**PLANNING BOARD AGENDA**  
**APRIL 27, 2016 – 7:00 P.M.**

RE: Meadowland Extension Site Plan  
1979 US Route 6  
Tax Map No. 55.15-1-20

**Site Plan Review Comments:**

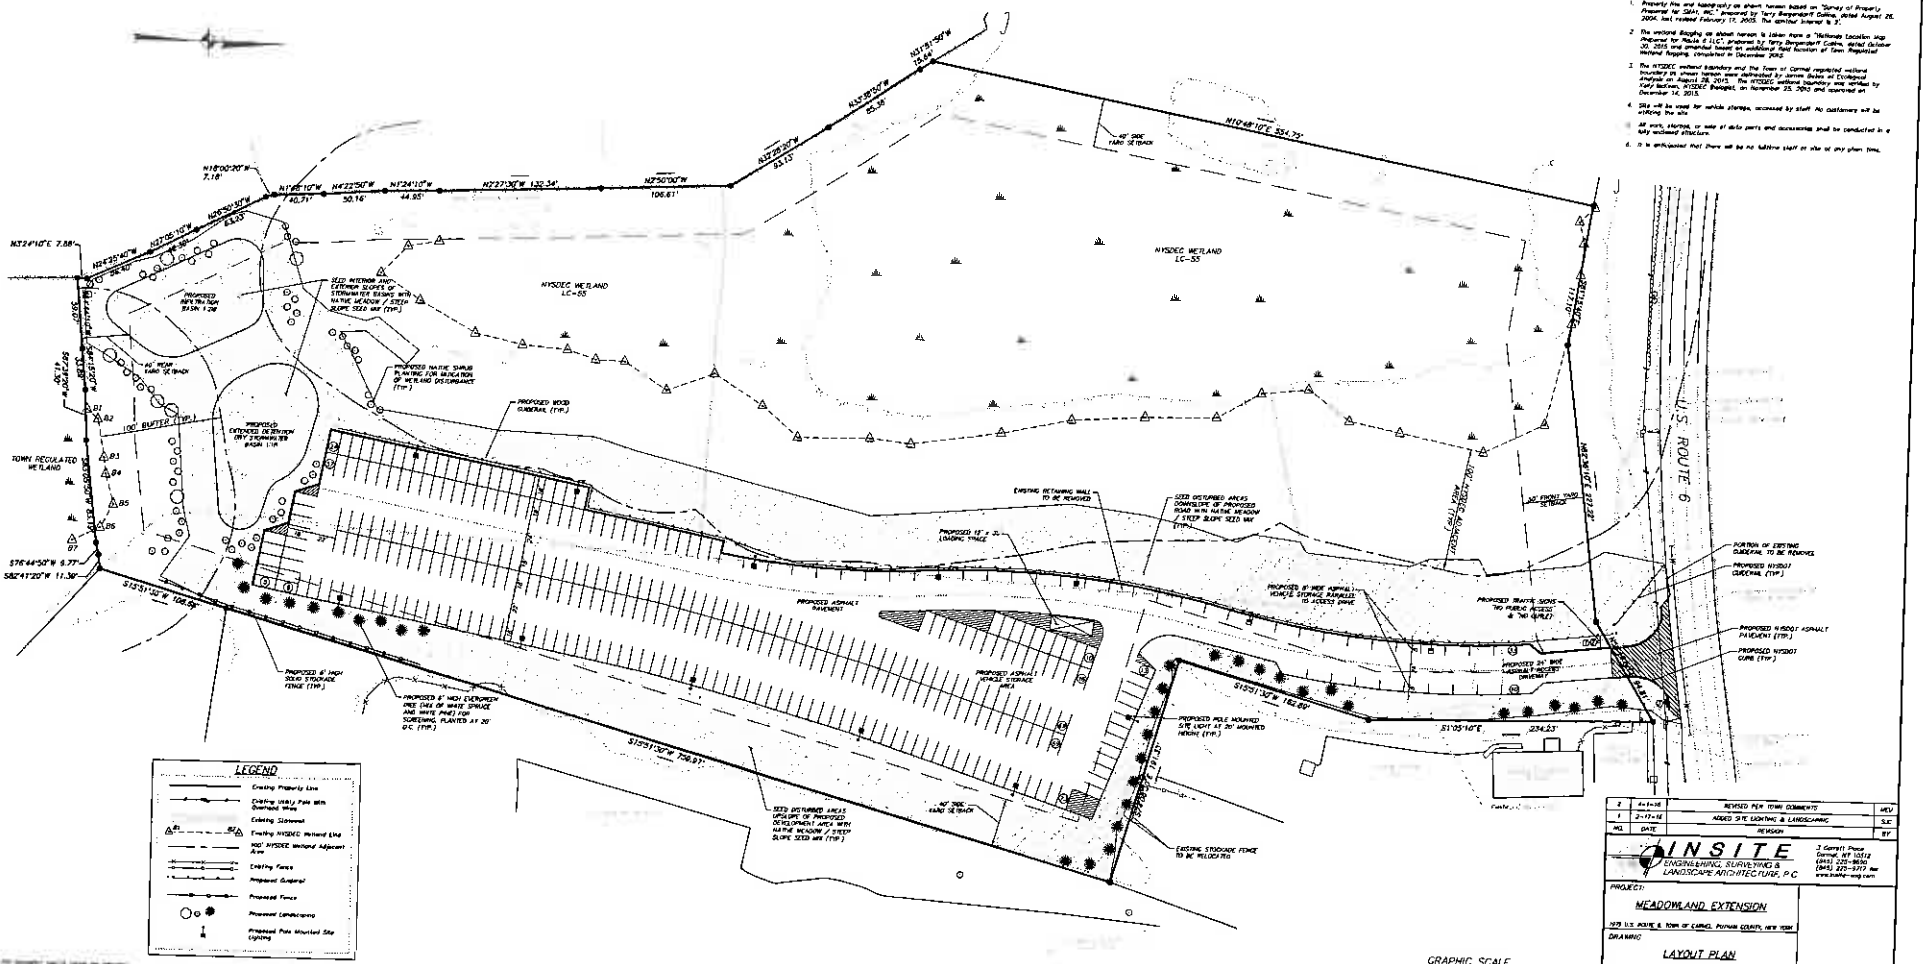
11. A "No Outlet" sign and a "No Public Access" sign are provided at the entrance to the site and a "STOP" sign is provided at the exit of the site as shown on Drawing SP-1.
